**Re: 49 CFR Part 573; Recall of Mercedes-Benz S and CL-Class**

### Voluntary Recall Campaign MY 2000 - 2001 S and CL-Class Blower Motor Fuse Holder

Campaign No. 2004070010

SUBJECT: **MODELS 215/220**  
**MODEL YEARS 2000 THROUGH 2001**  
**INSTALLATION OF BLOWER MOTOR WIRING HARNESS**

Figure 2

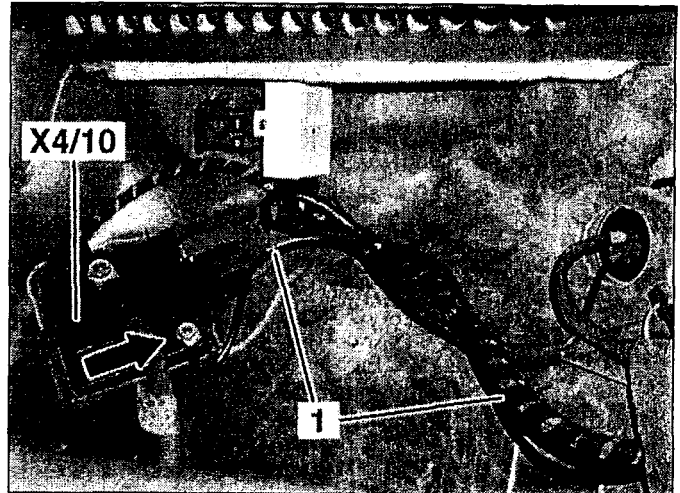
1. Route new interior blower motor wiring harness (1, Figure 2) with ring connector from the right fuse box (F1/1, Figure 3) into the right front footwell.

2. Route new interior blower motor wiring harness (1, Figure 2) along existing cables to the cable connector and fuse box terminal 30 (X4/10) and secure with cable ties.
3. Connect ring connector to designated M8 screw connection and torque M8 nut (arrow, Figure 2) to 9 Nm. (+ / - 1 Nm).

Figure 3

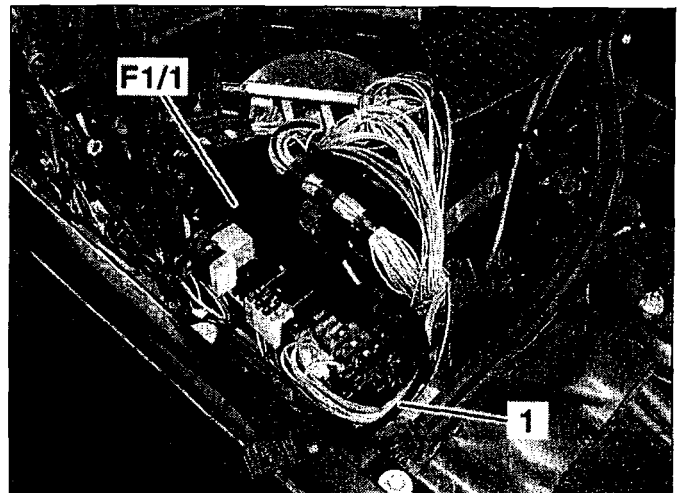
4. Remove brown fuse holder (fuse 35, Figure 4) with 40A fuse from the right fuse box (F1/1, Figure 3).
5. Unpin wire connector (with r/y wire, Figure 4) from brown fuse holder (35):
  - Remove fuse from fuse holder (35).
  - Unclip two outer locking tabs (A, Figure 4) furthest from the hinge (B) then partially pry open cover.
  - Unclip two outer locking tabs (C, Figure 4) closest to the hinge (B) then fully open cover to expose wire connectors.
  - Push the wire connector (with r/y wire) out from fuse side of fuse holder using special tools: Blade Handle W220 589 01 99 50 with blades W220 589 01 99 62 (both part of Wire Harness Kit W220 589 01 99 00 and W220 589 02 99 00).

**Figure 5**

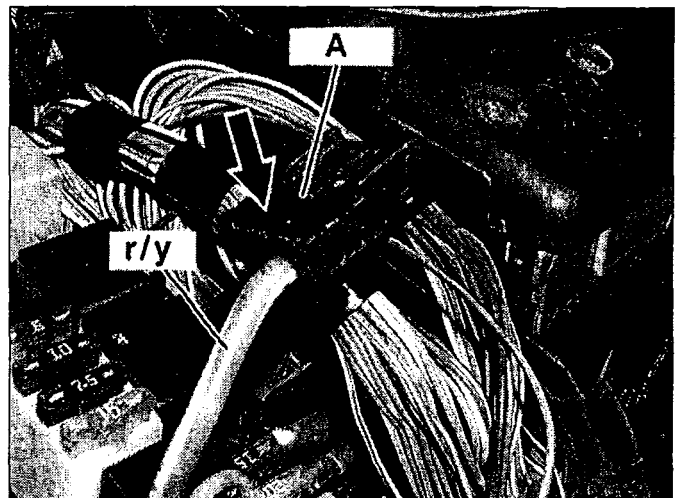
- The fuse holder (35) and fuse can be discarded.
  - r/y designates red/yellow wire.
6. Install unpinned wire connector (with r/y wire, Figure 5) into new harness connector (A):
    - Insert the unpinned wire connector (with r/y wire, Figure 5) into position 1 of the new harness connector (A).
    - Secure wire connector (with r/y wire) into position by locking closed the harness connector cover (arrow).

Figure 6

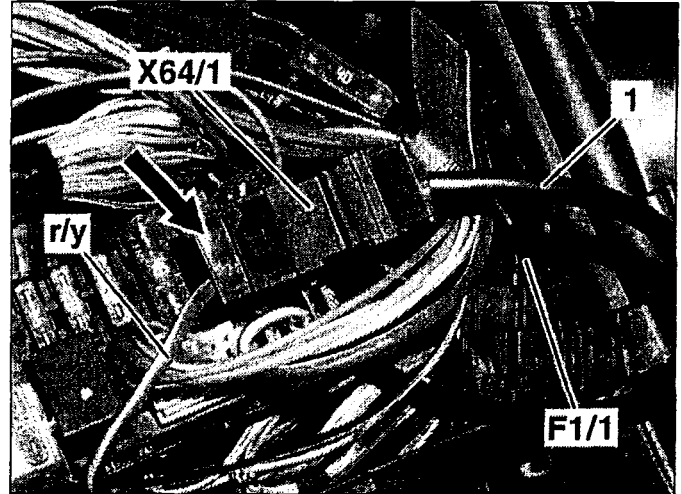
7. Connect the new harness connector (arrow, Figure 6) to the harness connector on the new blower motor harness wire (1) and place coupled connector (X64/1) below right front SAM in the right fuse box (F1/1).

Figure 7

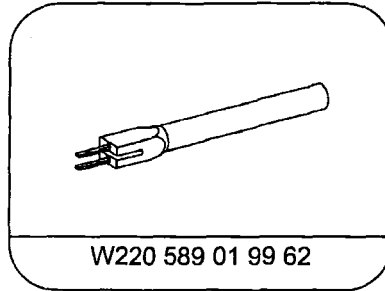
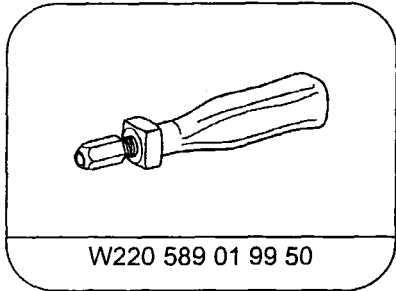
8. Install new maxi fuse holder (5, Figure 7) into grommet breakthrough (arrow) in right fuse box (F1/1).
9. Route interior blower motor harness below right front SAM in right fuse box (F1/1).
10. Reinstall right front SAM, reconnect wire harnesses to ME-SFI control module (if removed in step 4, subject A) and reassemble interior of vehicle in reverse order.
11. Reconnect battery ground cable WIS: AR54.10-P-0003I.
12. Read fault memory and erase using Star Diagnosis.
13. Check operation of interior blower motor.
14. Affix fuse/relay label over area of fuse chart identifying location of fuse/relays in **right front** fuse and relay box (fuses 28-49).  
**Note:** Fuse and relay chart is located in trunk under lug wrench (in tool kit).
15. Reinstall remaining parts in reverse order.
